APPLICATION FOR PERMIT TO DRILL OR REENTER

| 2. Name of Operator EOG RESOURCES INCORPORATED | | 8. Lease Name and Well No. STARK 33 FED COM |

**EOG RESOURCES, INC.
STARK 33 FED COM #703H**

**Proposed Wellbore
Design A**

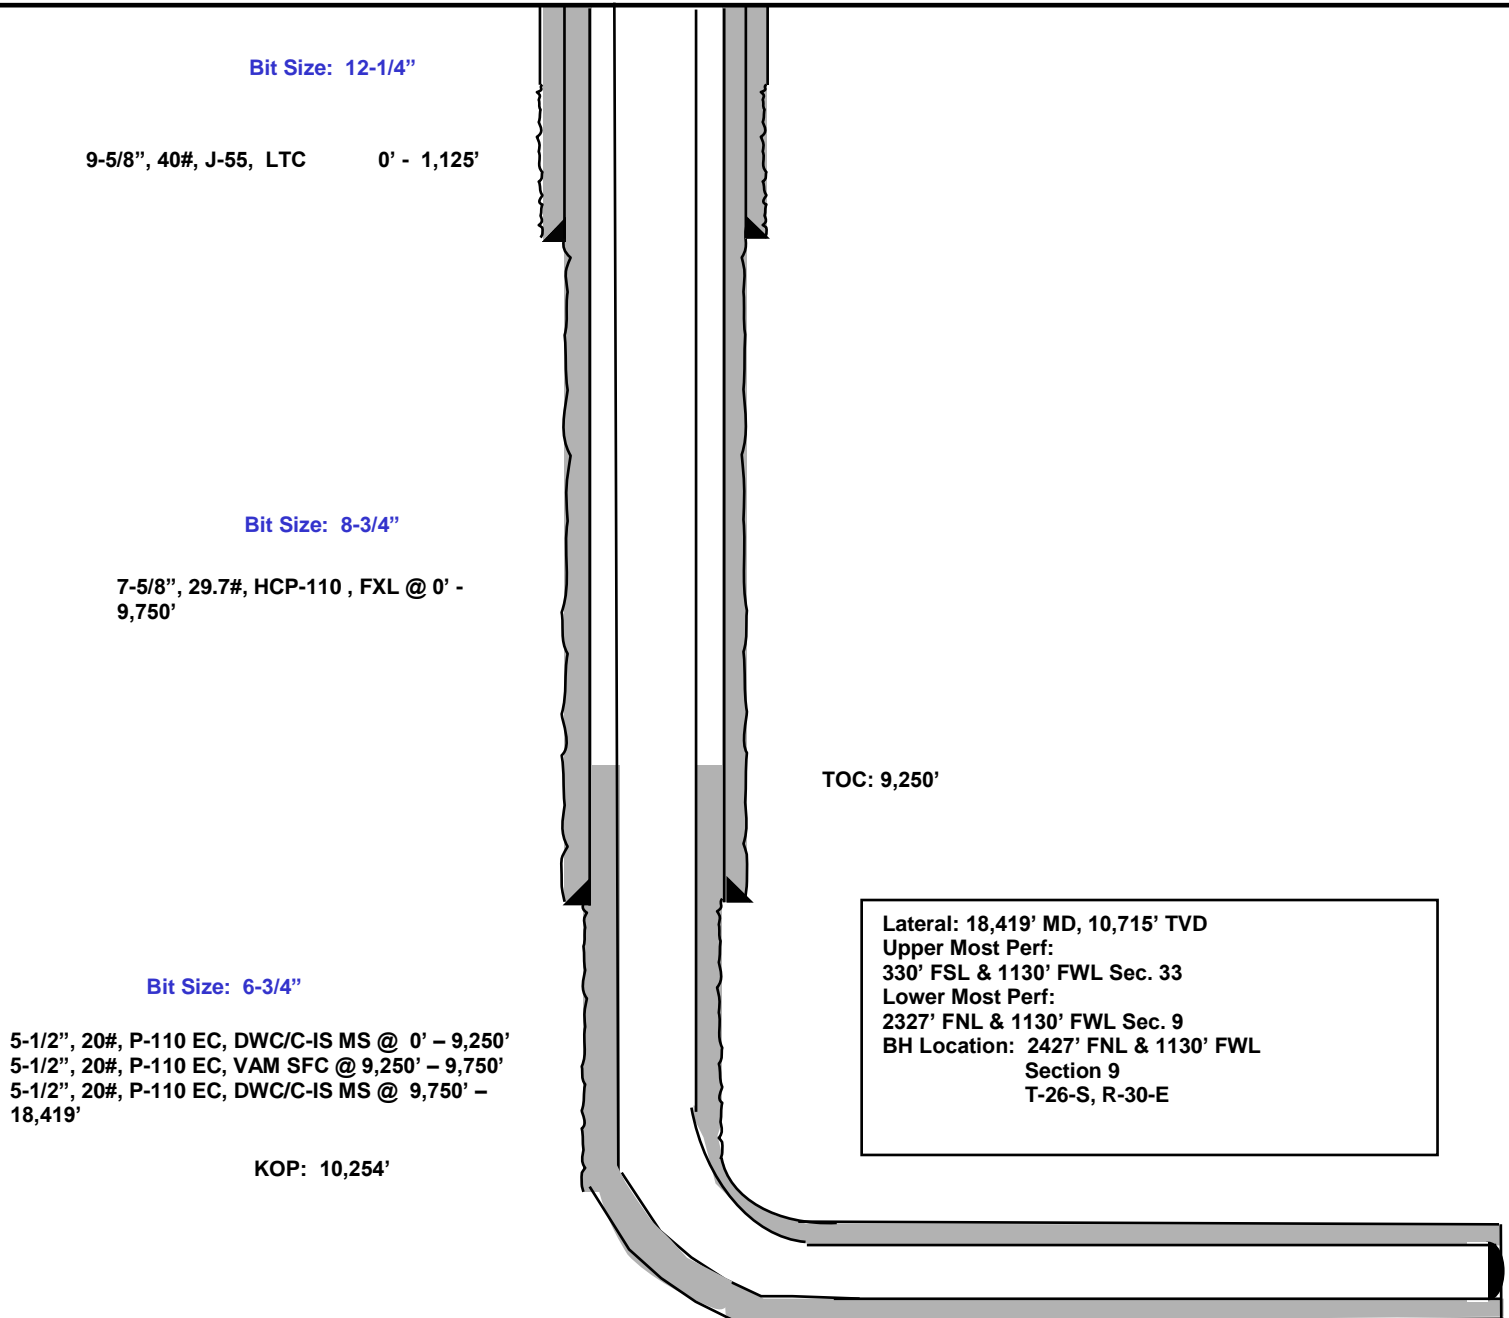
1. The **9-5/8** inch surface casing shall be set at approximately **1,125** feet (a minimum of **70 feet (Eddy County)** into the Rustler Anhydrite and above the salt) and cemented to the surface.
 - a. If cement does not circulate to the surface, the appropriate BLM office shall be notified and a temperature survey utilizing an electronic type temperature survey with surface log readout will be used or a cement bond log shall be run to verify the top of the cement. Temperature survey will be run a minimum of six hours after pumping cement and ideally between 8-10 hours after completing the cement job.
 - b. Wait on cement (WOC) time for a primary cement job will be a minimum of **8 hours** or 500 pounds compressive strength, whichever is greater. (This is to

Operator has proposed to pump down 9-5/8" X 7-5/8" annulus. Operator must run Echo-meter to verify fluid top and the volume of displacement fluid above the cement slurry in the annulus.

3. The minimum required fill of cement behind the **5-1/2** inch production casing is:
- Cement should tie-back at least **200 feet** into previous casing string. Operator shall provide method of verification.

Proposed Wellbore
Design B

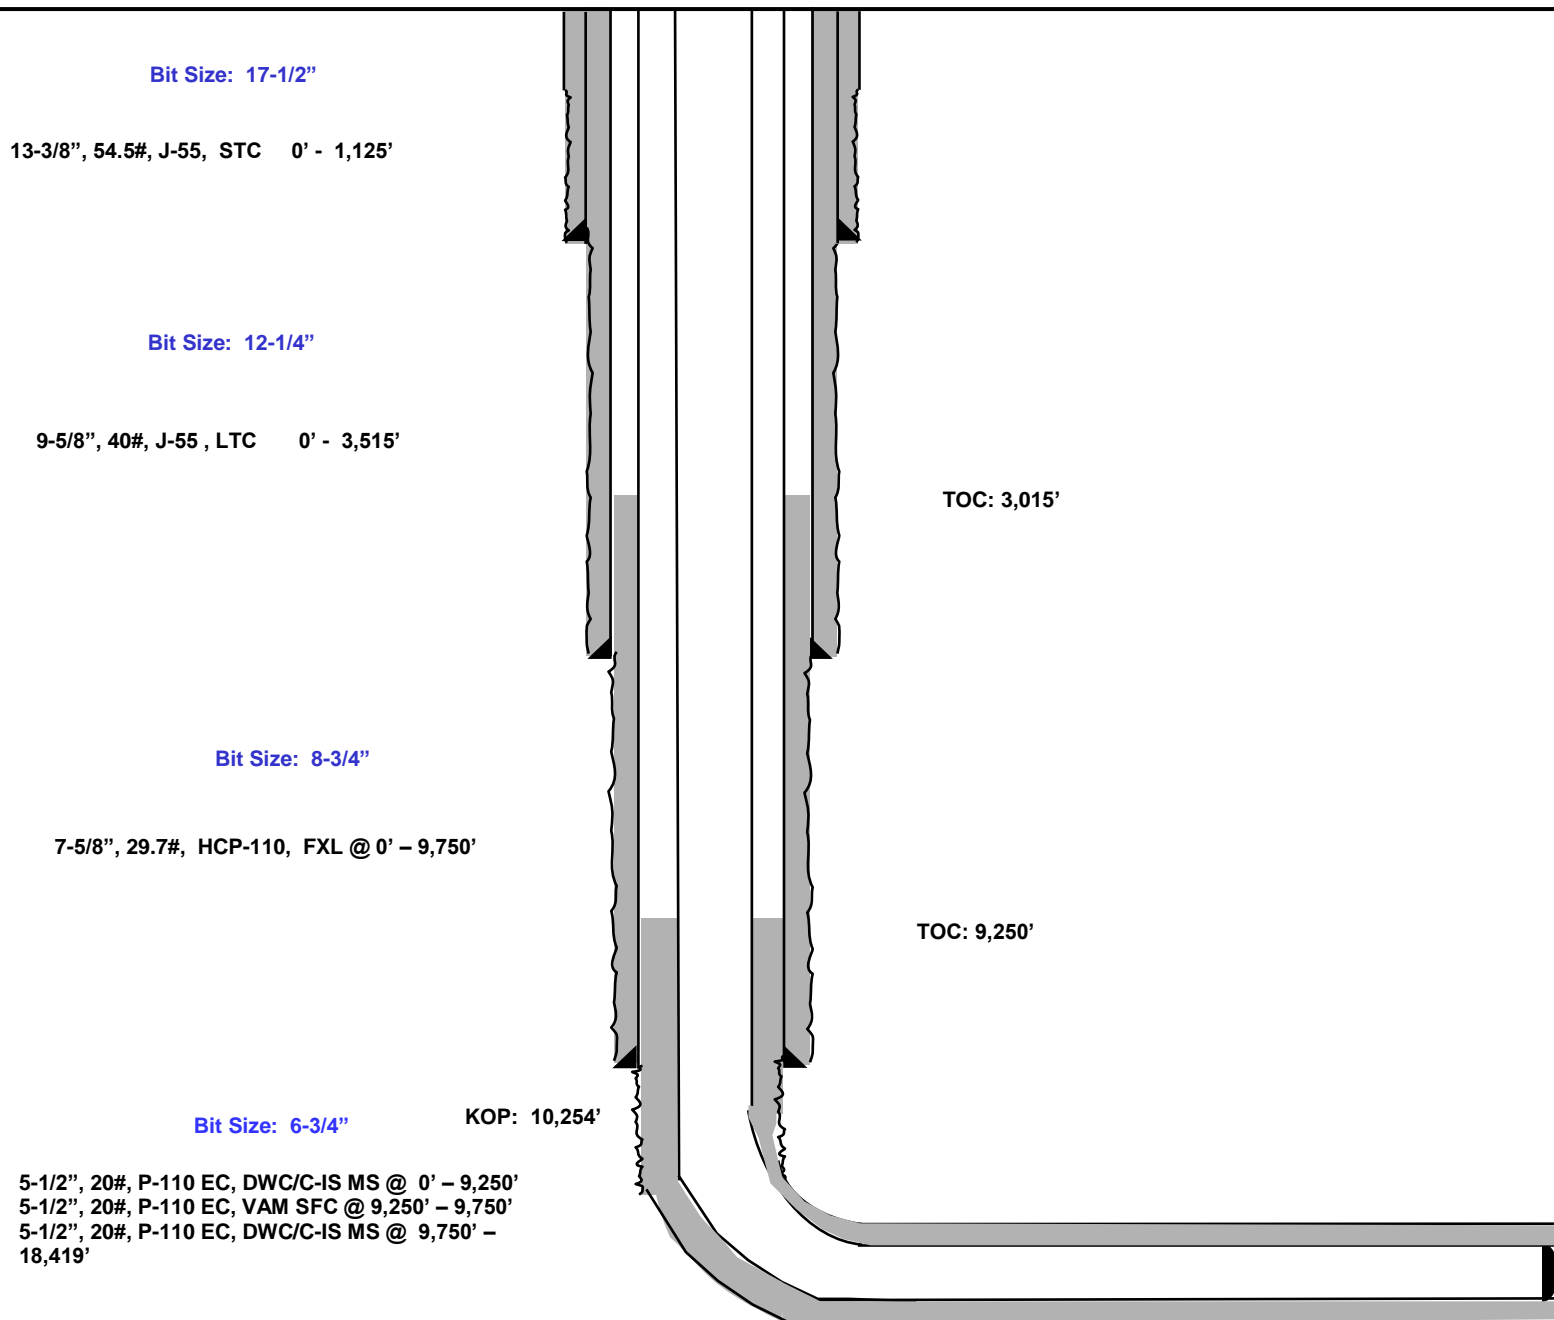
4. The **13-3/8** inch surface casing shall be set at approximately **1,125** feet (a minimum of **70 feet (Eddy County)** into the Rustler Anhydrite and above the salt) and cemented to the surface.
- a. If cement does not circulate to the surface, the appropriate BLM office shall be notified and a temperature survey utilizing an electronic type temperature survey with surface log readout will be used or a cement bond log shall be run to verify the top of the cement. Temperature survey will be run a minimum of six hours after pumping cement and ideally between 8-10 hours after completing the cement job.
 - b. Wait on cement (WOC) time for a primary cement job will be a minimum of **8**

- Operator will perform bradenhead squeeze. Cement should tie-back at least **200 feet** into previous casing string. Operator shall provide method of verification.

Operator has proposed to pump down 9-5/8" X 7-5/8" annulus. Operator must run Echo-meter to verify fluid top and the volume of displacement fluid above the cement slurry in the annulus.

7. The minimum required fill of cement behind the **5-1/2** inch production casing is:
- Cement should tie-back at least **200 feet** into previous casing string. Operator shall provide method of verification.
